From: Chris Stahl <cstahl@maconnc.org>
Sent: Monday, August 26, 2013 10:13 AM
To: Werner, Elizabeth
Cc: jhorton@maconnc.org; mark.cathey@mcgillengineers.com; Scott, Michael; Mussler, Ed; Gaither, Allen; Harrison, Troy; Lane, Ervin
Subject: Review of Landfill Gas Investigation at Highlands C&D Landfill - Closed; Permit #57-04
Attachments: Elizabeth Werner Letter 8-13.pdf; Highlands LF Gas Investigation Review 8-26-13.pdf

RE: Landfill Gas Investigation Review
Closed Highlands C&D Landfill
Macon County, North Carolina

HIGHLANDS CONSTRUCTION/DEMOLITION LANDFILL
MACON COUNTY
MACON COUNTY, NORTH CAROLINA

SHEET
C-101

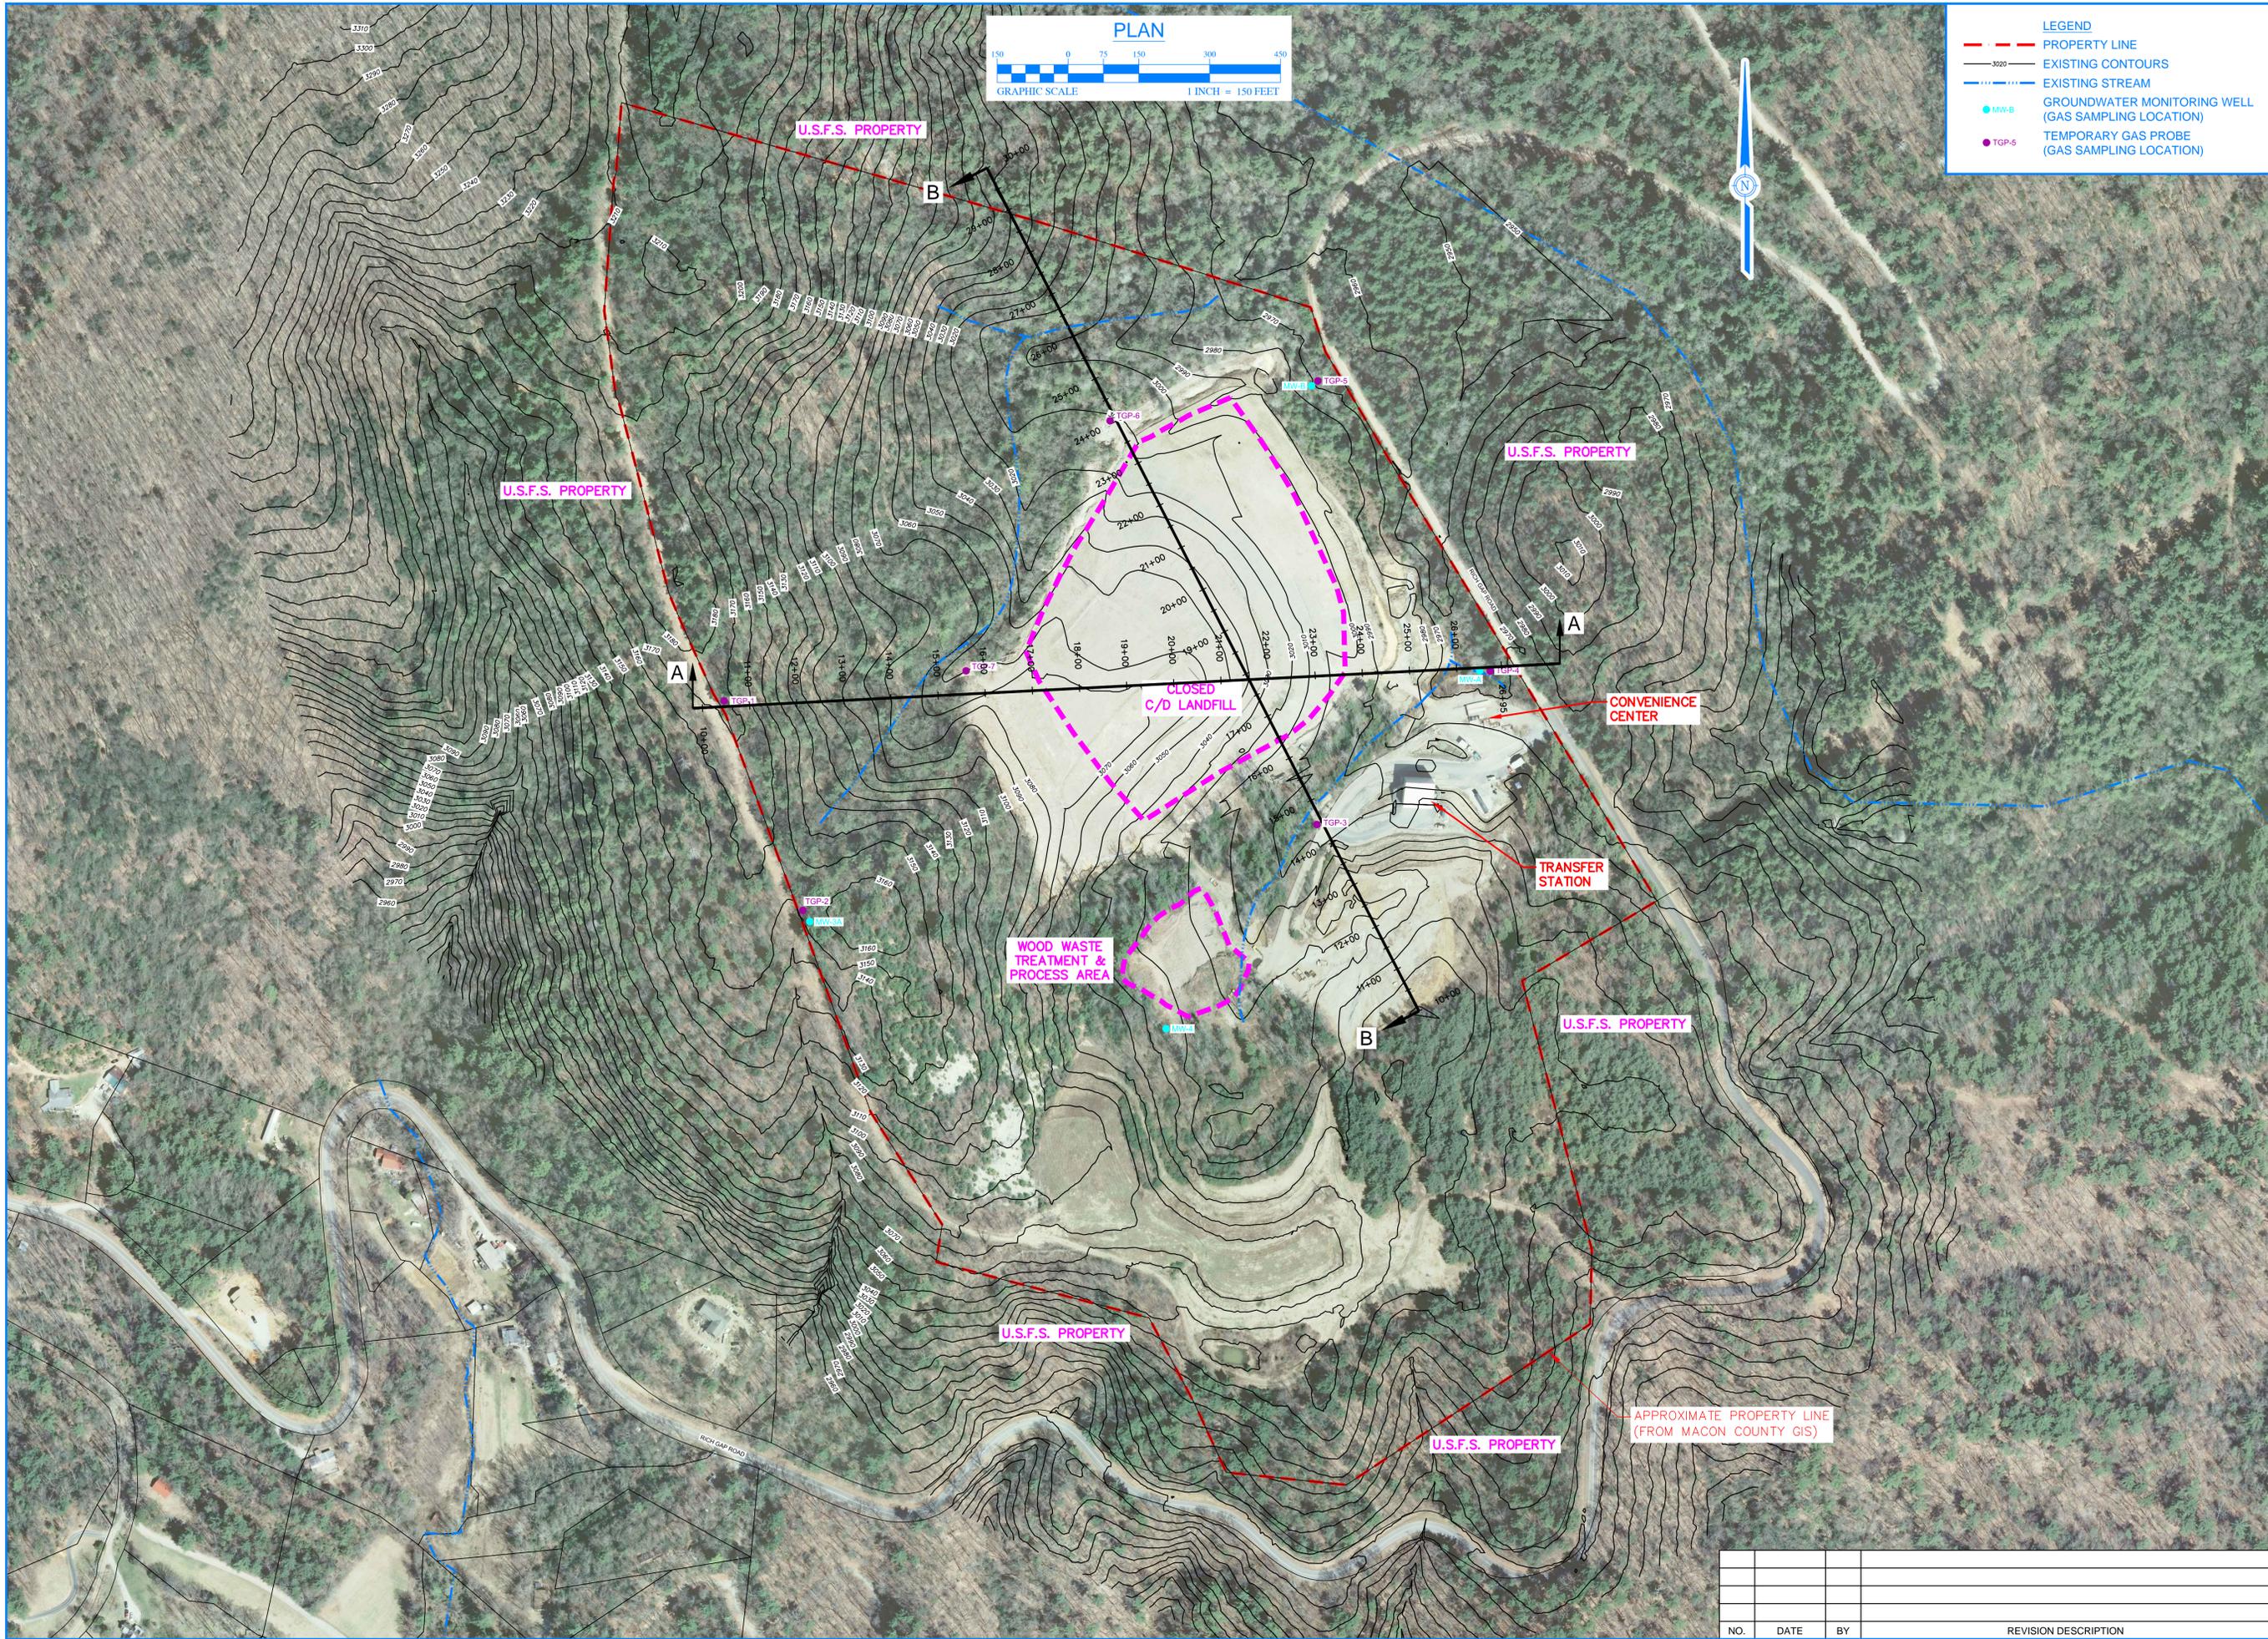
Equipped with the above-referenced information, McGill Associates prepared a "Gas Sampling Closure Compliance Plan" (attached Sheet C-101). This Plan includes an aerial photograph of the property and shows the property boundary, LIDAR contours of the property, C&D Landfill waste limits, final cap grades of the closed C&D landfill, locations of the temporary gas probes, and locations of pertinent groundwater monitoring wells. This Plan allows us to show the general horizontal and vertical relationships of the temporary gas monitoring locations relative to the landfill waste limits and the compliance boundary. Cross sections A-A (attached Sheet C-102) and B-B (attached Sheet C-103) were developed to show the relationship of the waste to the temporary gas monitoring locations.

1. The compliance boundary (property line) is approximately 225 feet from the C&D landfill waste limits at its closest proximity along the eastern property line. The compliance boundary is approximately 690 feet from waste along the western property line. The compliance boundary is approximately 300 feet from waste at its closest proximity along the northern property line, but averages approximately 700 feet. The compliance boundary is approximately 700 feet at its closest proximity along the southern property line. There are two streams bordering the landfill that run between the landfill waste limits and the property boundary outside the northern, southern, and eastern borders of the closed landfill.

2. TGP-1 and TGP-2 are located along the western compliance boundary (+/- 690 feet). MW-3A is also located adjacent to TGP-2 and was sampled in conjunction with the probe locations. No methane was detected at the time of sampling. Although the previous monitoring at these locations does show compliance to the depth tested, these probes are likely not highly efficient at monitoring landfill gas migration from the C&D landfill. However, it is our opinion that landfill gas would not migrate beyond the existing cut bank located along the western side of the closed landfill. Please refer to Sheet C-102. The soils at the site are sandy silts and have a relatively high permeability compared to clays and fine silts. Based on the soil type available for constructing the base liner and final cap of this facility and the shallow depth at which the waste was placed, it is illogical for this landfill, which contains a relatively modest volume of C&D waste, to produce methane in sufficient quantity to force migration beyond the areas immediately adjacent to the landfill waste limits. We are of the opinion that it is not physically possible for landfill gas to migrate to the western compliance boundary of this facility.

4. TGP-4 and TGP-5 are located along the eastern compliance boundary and adjacent to Rich Gap Road and monitoring wells MW-A & MW-B. They are located approximately 300 feet and 165 feet respectively from the waste limits and approximately 50 feet from the eastern compliance boundary. In addition to these temporary locations, MW-A and MW-B were also sampled for methane. No methane was detected at the time of sampling. The exact waste depths of the easternmost waste trenches are unknown. However, we have estimated the waste depths near the northeast corner of the cell to be the deepest in the landfill relative to adjacent grade, and approximately 15 feet deep. Therefore, we have estimated the bottom of waste elevation to be approximately 2980-2985 along the eastern side of the landfill. The temporary probe locations are located at an elevation of approximately 2970 and are located in an area where groundwater is approximately 5 feet deep. These probes should provide a representative sample of gas migration from the closed landfill.

SHEET
C-103

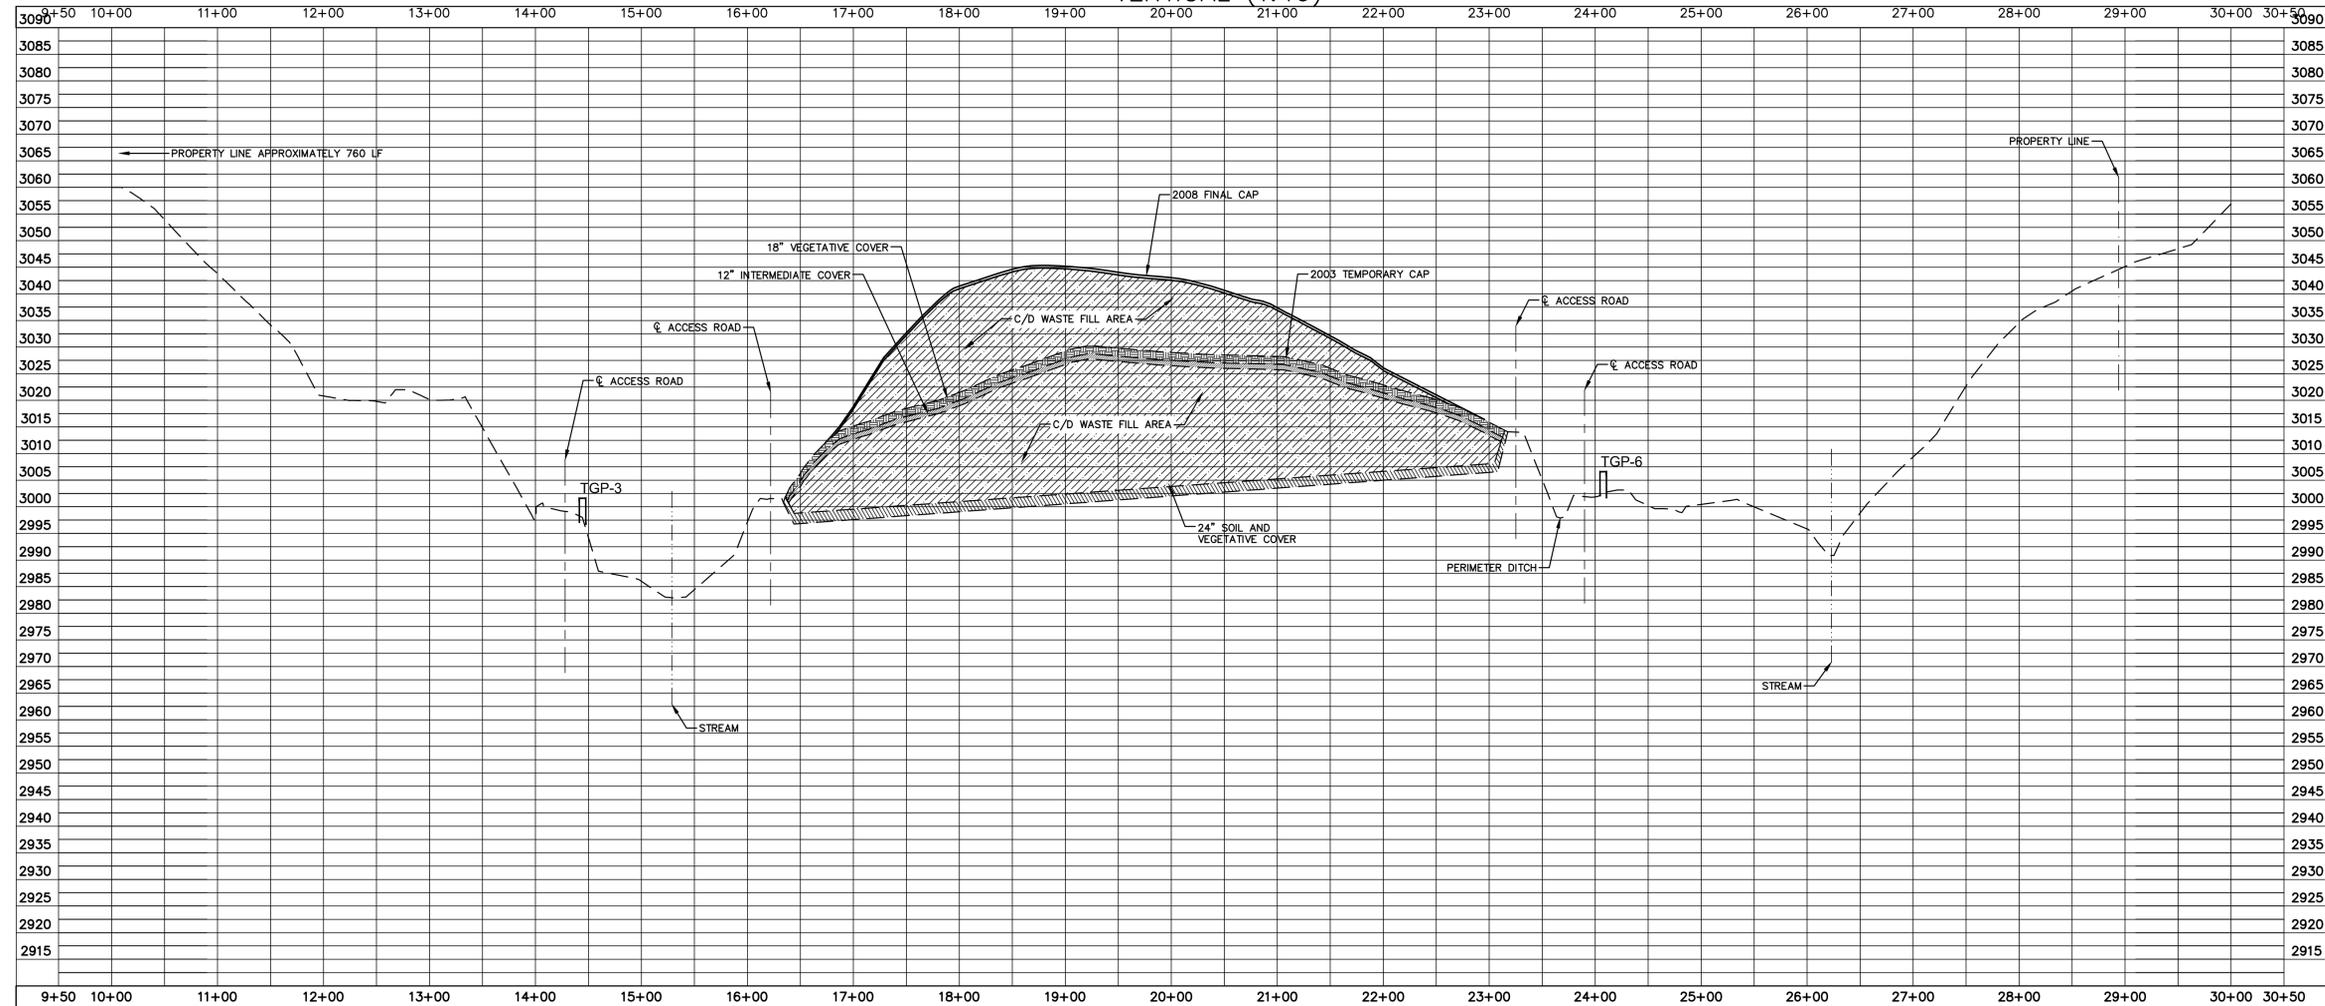
3. TGP-3 is located approximately 195 feet south of the landfill waste limits, with a stream located between the landfill and TGP-3. MW-4 is also located south/southwest of the landfill, but approximately 450 feet from the landfill limits. MW-4 was sampled for methane at the time the other temporary probes were sampled. No methane was detected at the time of sampling. TGP-3 has a sufficient depth relative to the bottom of waste depth and should provide a representative sample for gas migration in the southern direction. MW-4 is too far from the C&D waste limits to be a representative methane sampling location for the facility. Any gas migration in this direction would likely occur through the cap and/or the down-gradient slope located between the southern waste limits and the stream. Please refer to Sheet C-103.

5. TGP-6 is located approximately 70 feet from the northern waste limits of the cell. TGP-6 did show a 0.4% methane concentration (8% LEL) at the time of sampling. This concentration is well within the compliance range of < 5.0% methane, which is required at the compliance boundary, some 300+ feet away. Installing TGP-6 at a greater depth would have potentially improved its effectiveness for monitoring migration to the north, but the compliance boundary is located 300+ feet away from the waste limits and is located beyond a stream that is located north of the cell limits. Any gas migration in this direction would likely occur through the cap and/or the down-gradient slope located between the northern waste limits and the stream. Please refer to Sheet C-103.
